ADDENDUM NO.: 3
 DATE OF CMR ADDENDUM: 1/24/2014

Project Name:	Renovations and Additions to Emmett O'Brien Technical High School
Project Location:	141 Prindle Avenue, Ansonia, Connecticut
CT DCS Project Number:	BI-RT-844-CMR

ADDENDUM NO. 3

**Renovations and Additions to
Emmett O'Brien Technical High School
141 Prindle Avenue
ANSONIA, CONNECTICUT
Project # BI-RT-844-CM-R**

REF. DWG C4
ADDENDUM 3
SKC-005

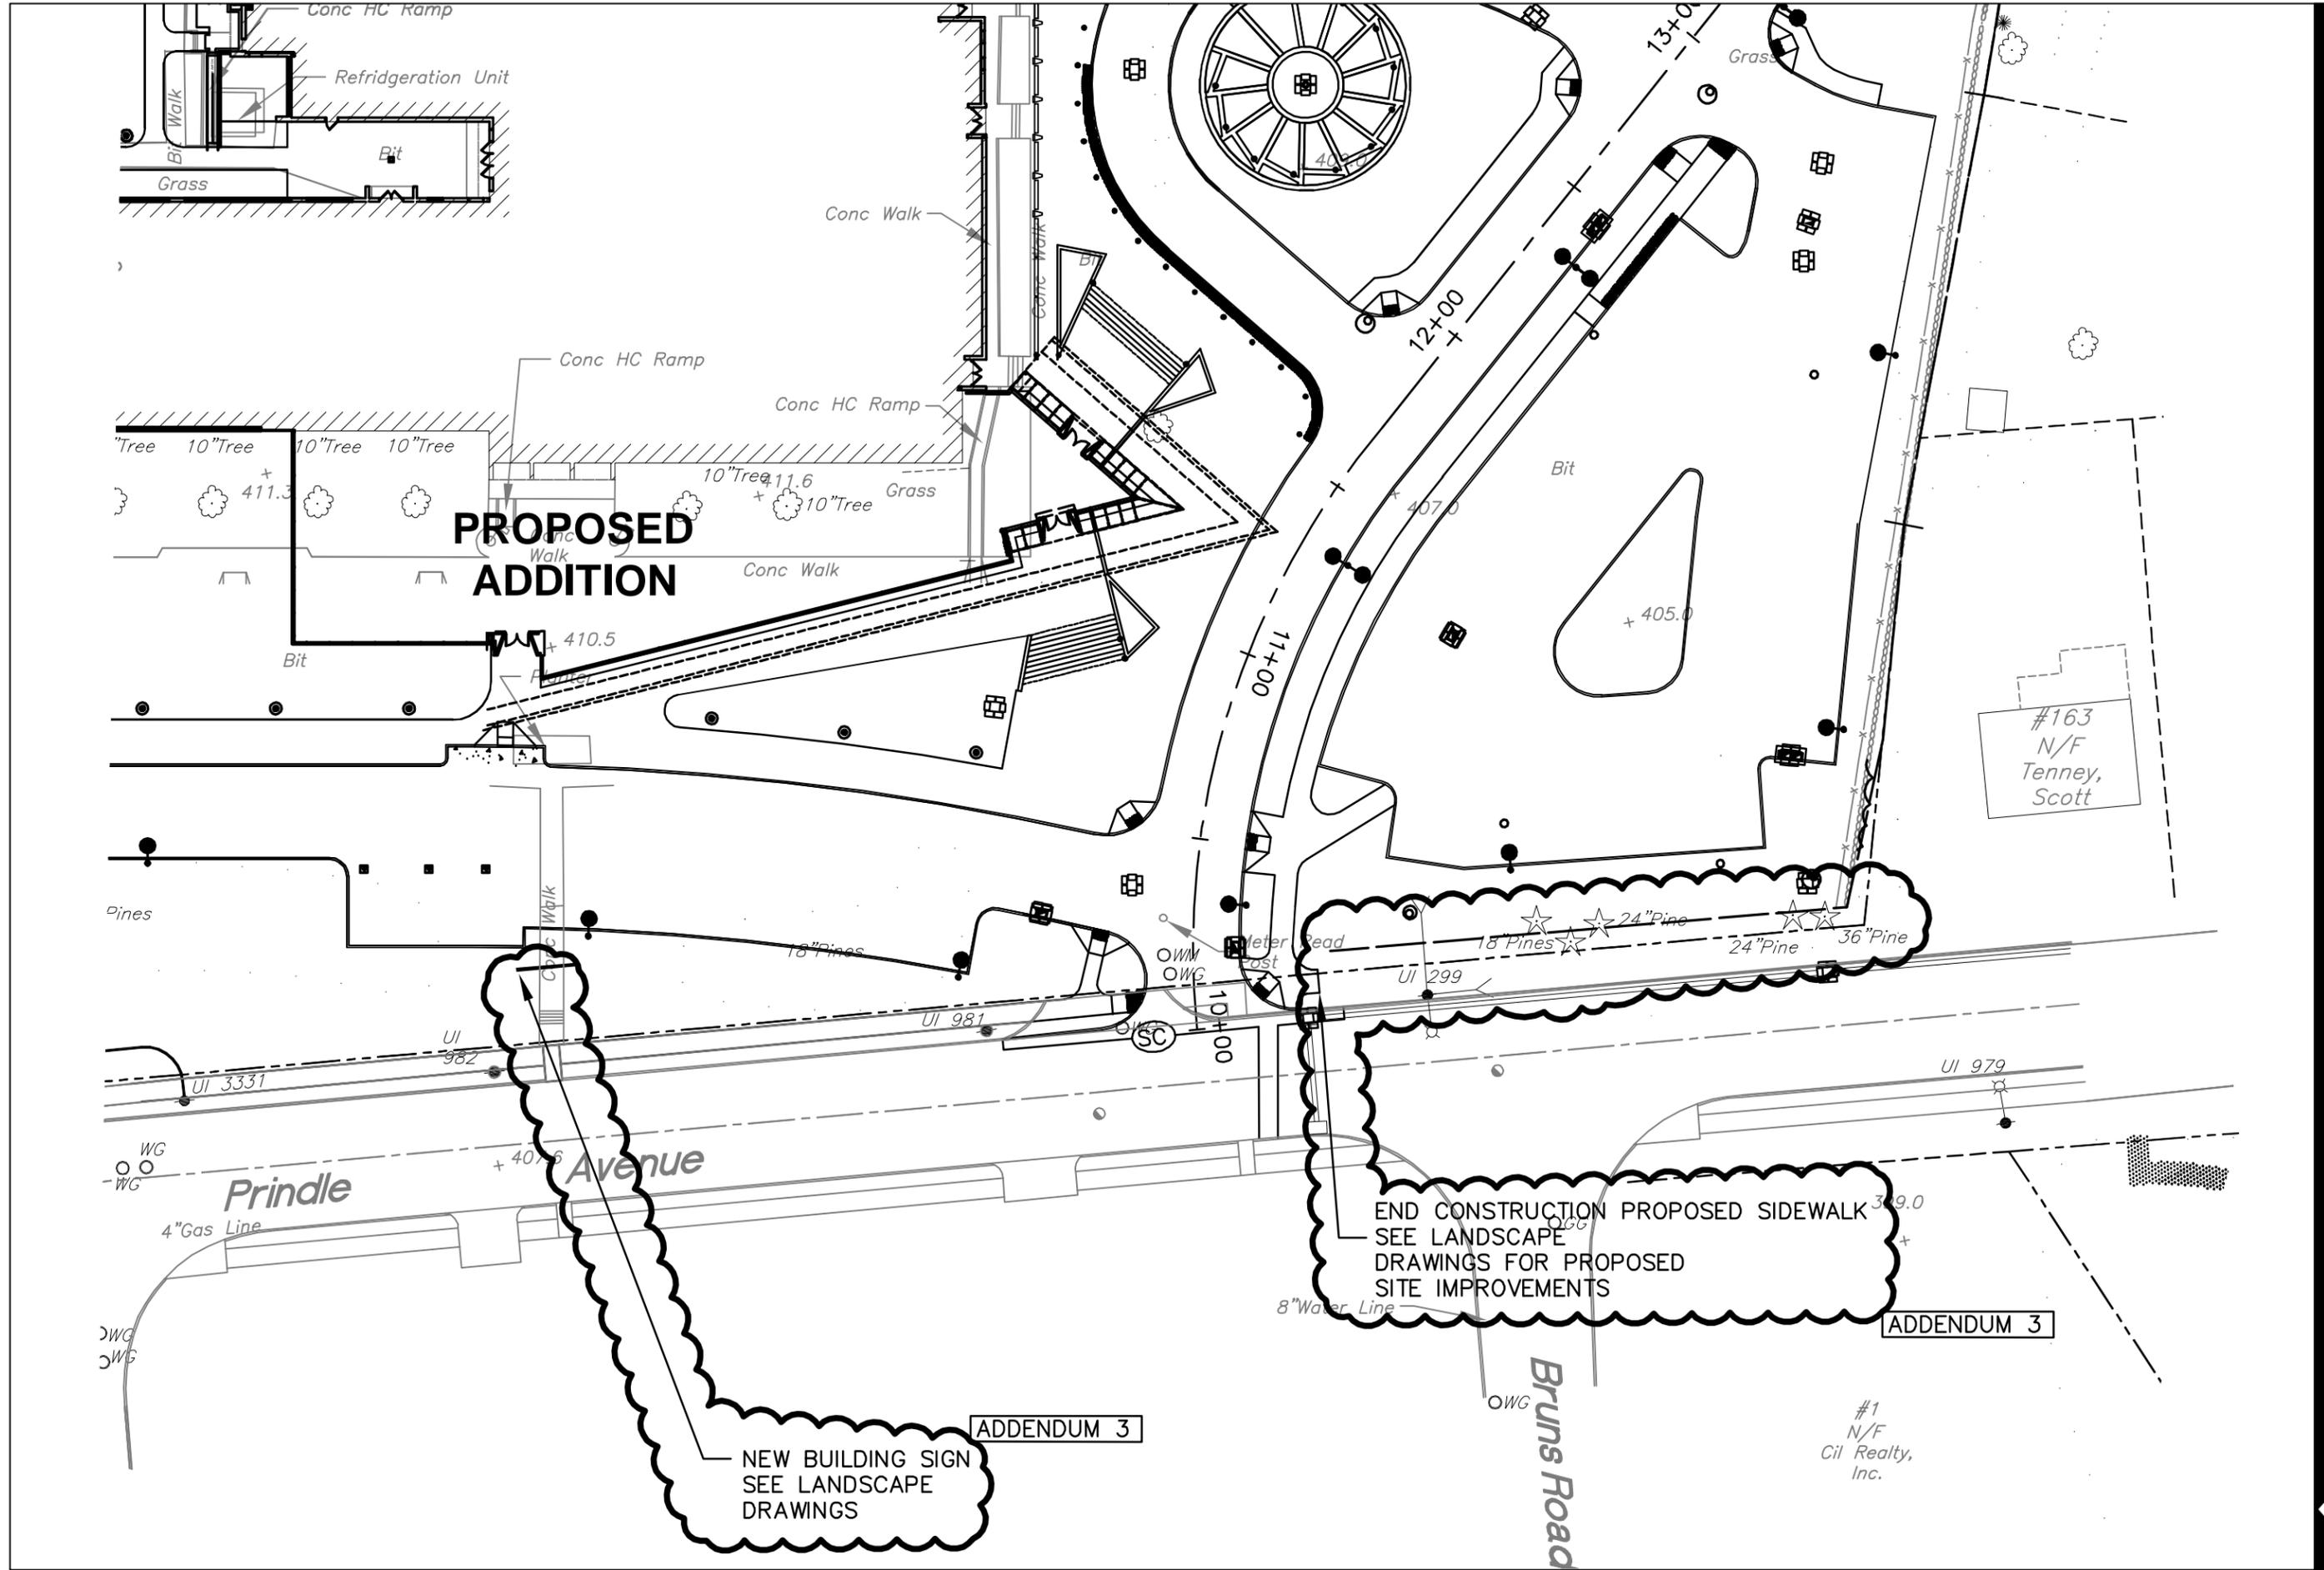
Emmett O'Brien Technical High School, Ansonia, Connecticut
**ADDED BUILDING SIGN NEAR PRINDLE AND
ELIMINATED SIDEWALK AT SOUTH PARKING LOT**

REVISE drawing per attached sketch SKC-005.

SKA-002

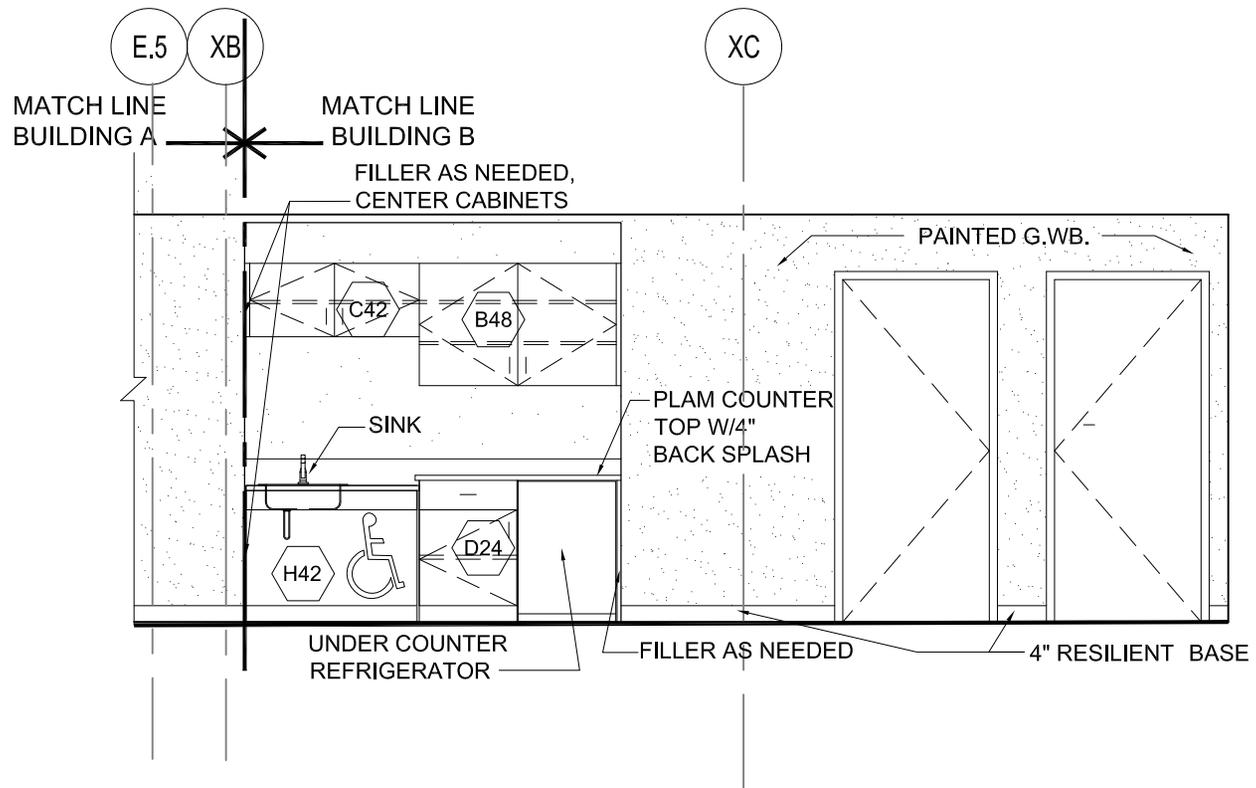
At Room H105f, Dispensary Room, Delete elevation tag “5/A2.2.1H.”
- ADD 3-035 A2.2.2A – INTERIOR ELEVATIONS AREA A**
Interior Elevation 14: Revise per attached sketch SKA-002.
- ADD 3-036 A2.2.1B – INTERIOR ELEVATIONS AREA B**
Interior Elevation 17: Revise per attached sketch SKA-003.
- ADD 3-037 A4.1.1 – ENLARGED TOILET PLANS**
Enlarged Plan No. 3: At Toilet & Shower Room A114b, REVISE both dimensions for handicap shower stall to read “3'-0” CLEAR.”
